CITY PLAN COMMISSION**THURSDAY, January 15, 2026****FILE NUMBER:** PLAT-25-000172**SENIOR PLANNER:** Hema Sharma**LOCATION:** Wheatland Road, east of County View Road**DATE FILED:** December 18, 2025**ZONING:** MF-2(A)**CITY COUNCIL DISTRICT:** 3**SIZE OF REQUEST:** 3.775-acres**APPLICANT/OWNER:** TX James Apts. 2025 LTD

REQUEST: An application to create one 3.775-acre lot from a tract of land in City Block 10/8604 on property located on Wheatland Road, east of County View Road.

1:2,400	AERIAL MAP <input type="checkbox"/> Area Of Request <input type="checkbox"/> Recent History	Case no: PLAT-25-000172 Date: 12/23/2025
--	--	---

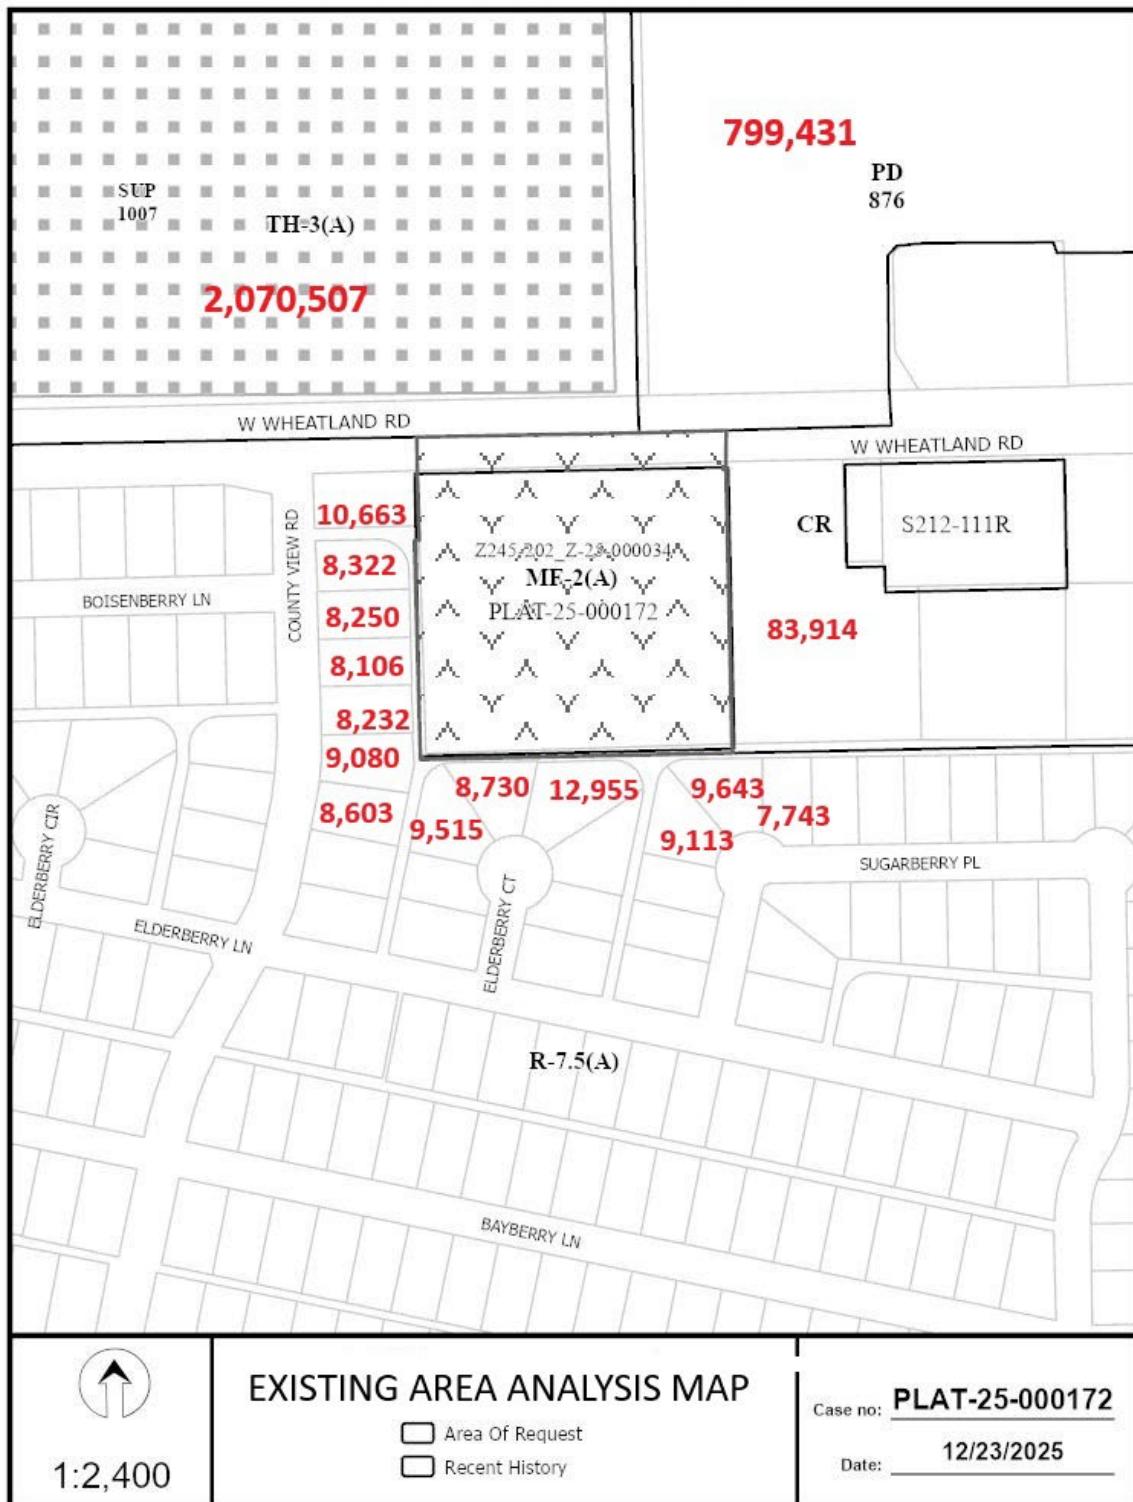
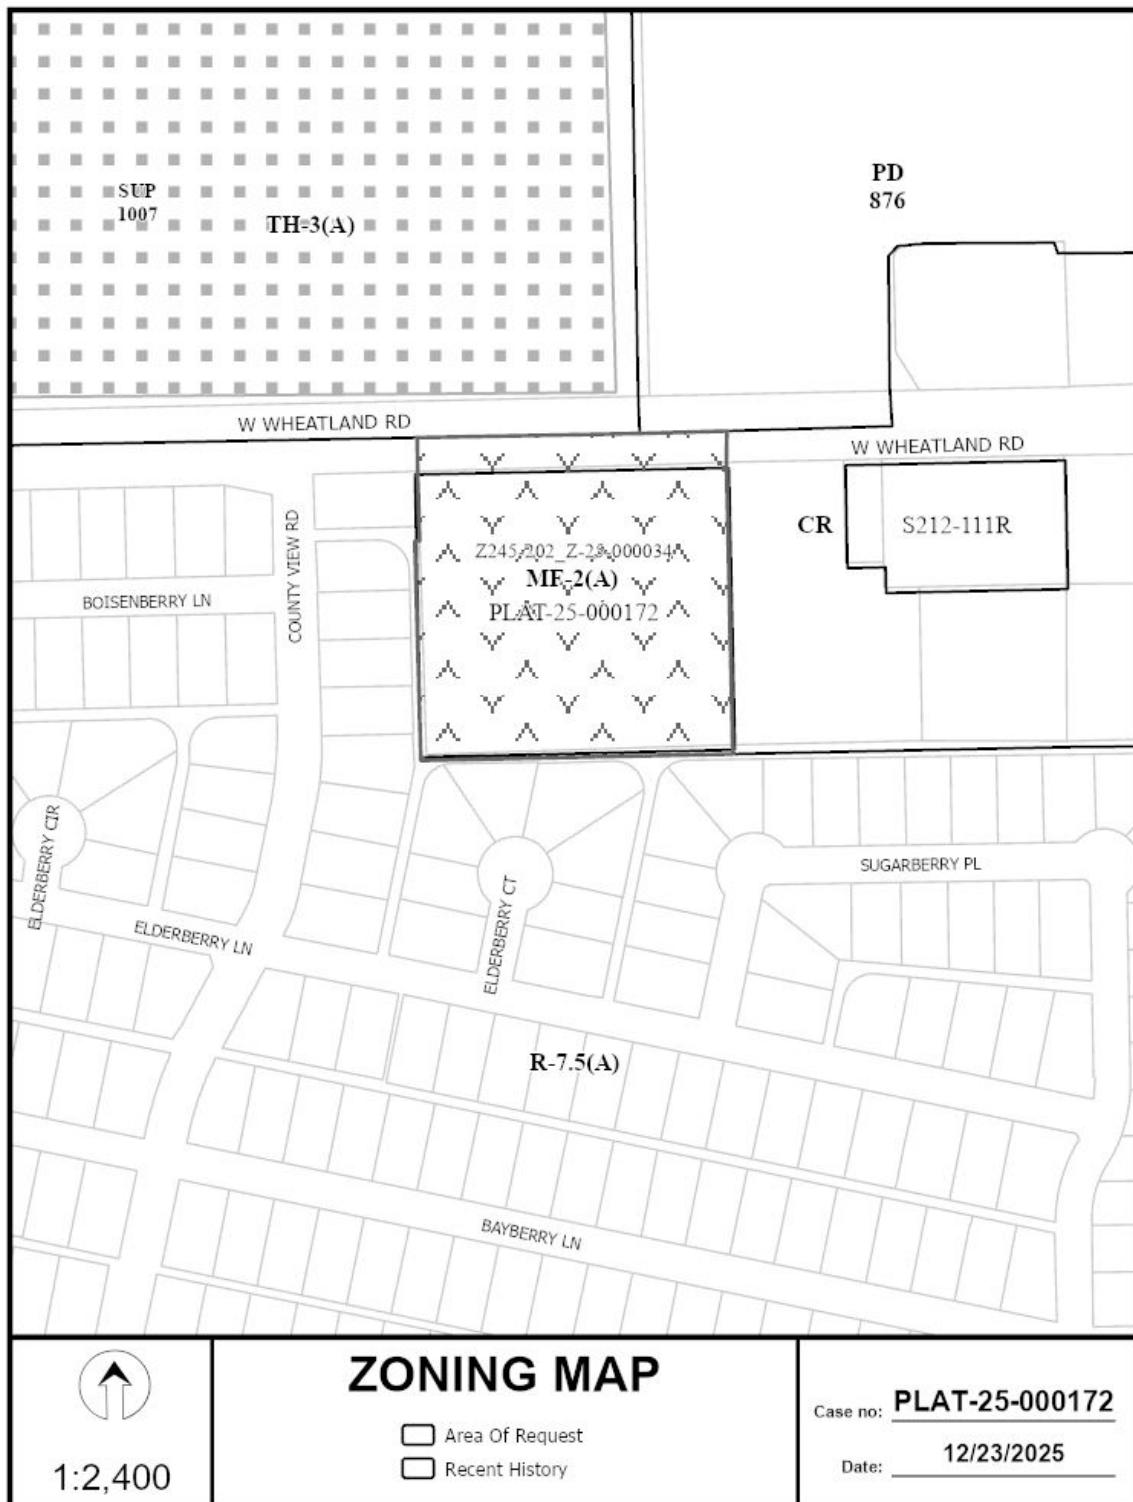
7. On the final plat, include two boundary corners tagged with these coordinates: "Texas State Plane Coordinate System, North Central Zone, North American Datum of 1983 on Grid Coordinate values, No Scale and no Projection."

11. The number of lots permitted by this plat is one.

15. On the final plat, dedicate 50 feet of right-of-way (via fee simple) from the established center line of Wheatland Road. *Section 51A 8.602(c)*
16. On the final plat, dedicate a 15-foot by 15-foot Alley Sight Easement at the intersection of Alley & the alley. *Section 51A-8.602(e)*
17. Provide minimum alley ROW at the alley bend per City of Dallas Standard Construction Details File 251D-1 Page 1012.

18. Prior to final plat, submit a completed final plat checklist and all supporting documents.
19. On the final plat, show recording information on all existing easements within 150 feet of the property.
20. On the final plat, show all additions or tracts of land within 150 feet of the property with recording information. Platting Guidelines.

21. Additional design information is required for assessment. Site plan must be submitted showing proposed development, building finished floor elevation, development, existing mains – including downstream manhole, and proposed water and wastewater service locations. Submit water/wastewater engineering plans to 320 E. Jefferson Blvd., Room 200, Attention: Water and Wastewater Engineering.
22. Water and Wastewater main improvements is required by Private Development Contract. Submit water/wastewater engineering plans to 320 E. Jefferson Blvd., Room 200, Attention: Water and Wastewater Engineering.
23. Existing and any proposed Water and Wastewater Easements must be shown and/or increased to conform to current design standards. **Notice:** Minimum DWU easement size 20' for one utility and 25' for both water and sewer. Larger diameter or deeper mains may require additional width.

24. Additional design information needed to complete review. Provide a brief description of the proposed project and a copy of the site plan to daniel.silva1@dallas.gov to determine street lighting requirements.
25. On the final plat, change "Sugarberry Road" to "Sugarberry Place". Section 51A-8.403(a)(1)(A)(xii).
26. On the final plat, add "Boisenberry Lane"
27. On the final plat, identify the property as Lot 4 in City Block 10/8604.
